**ADDENDUM I**

**SUBJECT:** Formal Invitation For Bid (IFB) 6100012629 Annual Contract for Brush Tractor Trucks and Trailers scheduled to open March 30, 2020, date of issue March 13, 2020.

### **ADDENDUM III**

**SUBJECT:** Formal Invitation For Bid (IFB) 6100012629 Annual Contract for Brush Tractor Trucks and Trailers scheduled to open April 8, 2020, date of issue March 13, 2020.

Photo 1: Horizontal Exhaust.

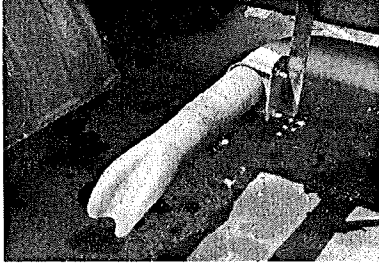
- 4.3.13 EXHAUST SYSTEM: Muffler, horizontal tailpipe, heat guard, and turn out in front of rear tires. May be downward facing. See photo 1:

Photo 2: Rear of Tractor Truck

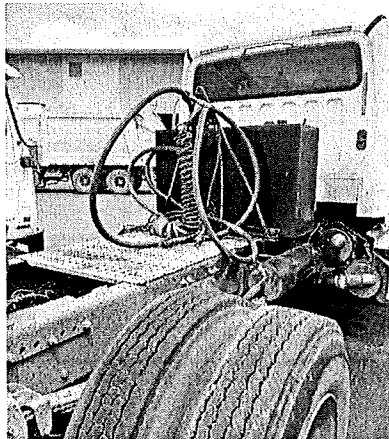
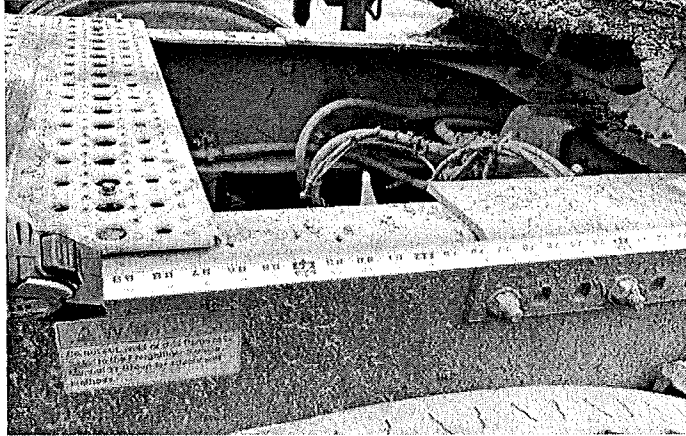
- 4.3.17 FIFTH WHEEL: Holland FW35 air slide with slide controls, or equivalent. Fifth wheel to extend above rear fenders as to not cause trailer contacting fender under operations in uneven terrain. Clearances needed for all operations of pins, trailer, fenders, and fifth wheel latch release must be considered when matching a rear ejection, horizontal discharge brush trailer. Slide length is fixed approximately 7' 3" at arrow see photo 2 & 3 below.

- 4.3.17 FIFTH WHEEL:** Holland FW35 air slide with slide controls, or equivalent fifth wheel to extend above rear fenders as to not cause trailer contacting fender under operations in uneven terrain. Clearances needed for all operations of pins, trailer, fenders and fifth wheel latch release must be considered when matching a rear ejection, horizontal discharge brush trailer. Slide length is minimum 24" approximately 7' 3" at arrow see photo 2 & 3 below.

Photo 4: Truck Clearance Loaded.

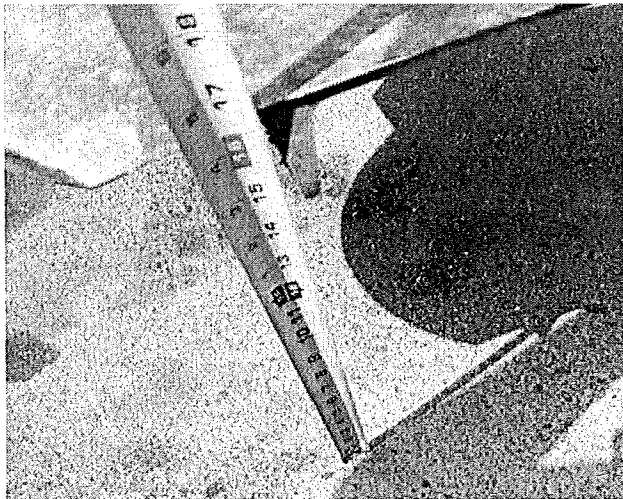
4.3.19 CLEARANCE: All items are required to be a minimum of 15" off ground, see photo 4 below.

Photo 5: Acceptable Door Design.

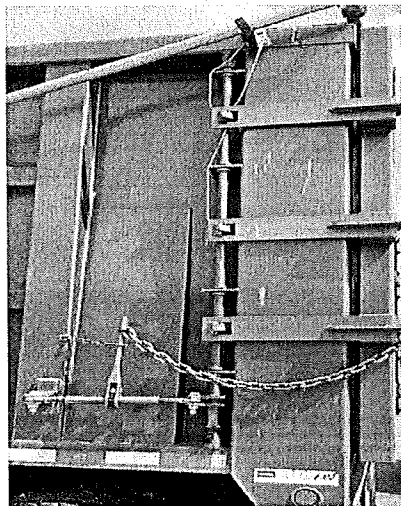
- 4.4.3 TAILGATE: "Barn door" type, hinged at right side of tailgate allowing tailgate to swing out fully to right side of trailer. Four hinges evenly spaced from top to bottom, with minimum 1/2" hinge pins. Heavy-duty provisions to secure door in full open position against body side required. Tailgate to be manufactured of minimum 10-gauge steel with boxed type reinforcements on all sides with basic sheet wrapped over top and under bottom. Base section must be sloped to form a dirt-free self-cleaning edge. A positive firm locking latch, which can be operated from ground level, will be used to secure the doors in the closed position. Minimum three (3) each, ratchet type cam locks, to be installed on left side of door to ensure proper door closure. All ratchets must open and close in same direction across total truck buy. See Photo 5 of Acceptable Door Design. Tailgate hold down chain brackets accessible in both open and closed positions. Design of door must include support of door on body platform instead of sides when doors are closed. All hinges will have Zert fittings to facilitate lubrication. Metal alignment ramp will be attached to aid in closing door.

**Photo 6: Acceptable Strap Design**

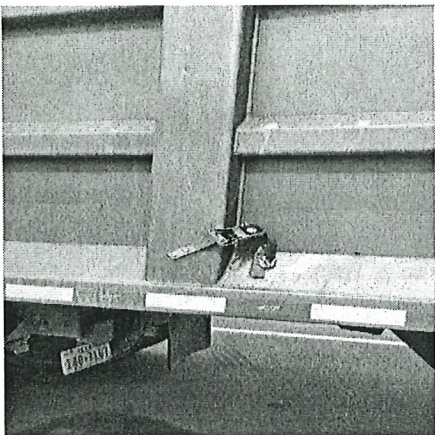
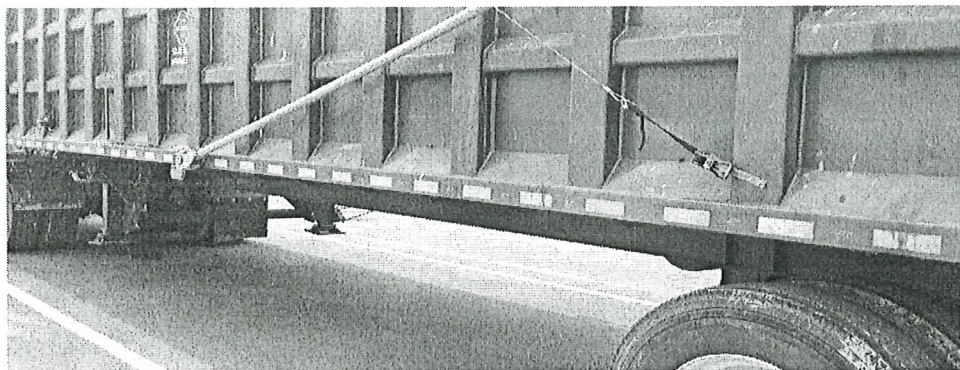
- 4.4.7 BODY COVER ASSEMBLY:** Tarp system to be Pull Tarps, Universal Super Shield Automated Arm System, part number S9EL, with steel arms, or equal. Motor to be mounted in the "down" position. A weather proof control panel, with a minimum 25-amp auto-reset breaker, to operate tarp system will be located in conjunction with the hydraulic controls and shall not be more than 6ft off the ground. Controls to operate the tarp system will not be placed in the cab of the tractor. Tarp material to be Pull Tarps Combo Mesh, or proven equal. Tarp bar hold down straps to be installed on the sides of the unit front and back of the trailer so operators can secure bars while in transit. Straps shall be supplied according to the photo; or supplied equivalent in function. **See photo 6, 7 and 8 for acceptable hold down strap Design**
